## Drawworks Cable Clamp

Figure 3: Secondary Cable Retention System

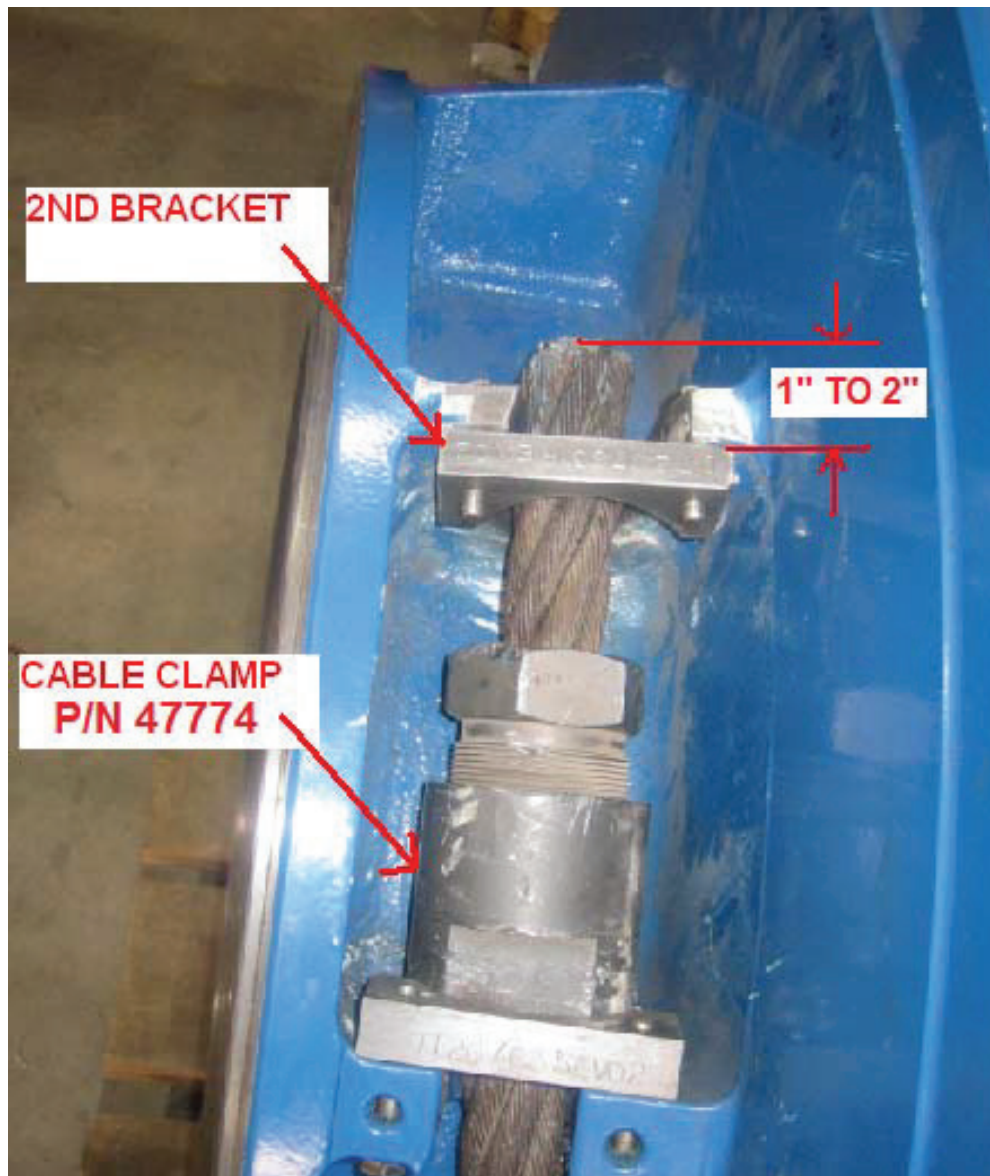
If the cable clamp is installed incorrectly, the pigtail can be caught on the brake assembly when running in either direction. The cable clamp (see Figure 1) can be pulled through the retainer plate, breaking the weld (see Figure 2 on page 2), damaging the drum flange, and striking the brake caliper.

Canrig recommends the installation of a secondary cable retention system. Install the cable such that 1–2 in. of cable extends beyond the second bracket (P/N DT20763) (see Figure 3). Turn the drum slowly in both directions to verify cable clearance and proper drawworks operation.
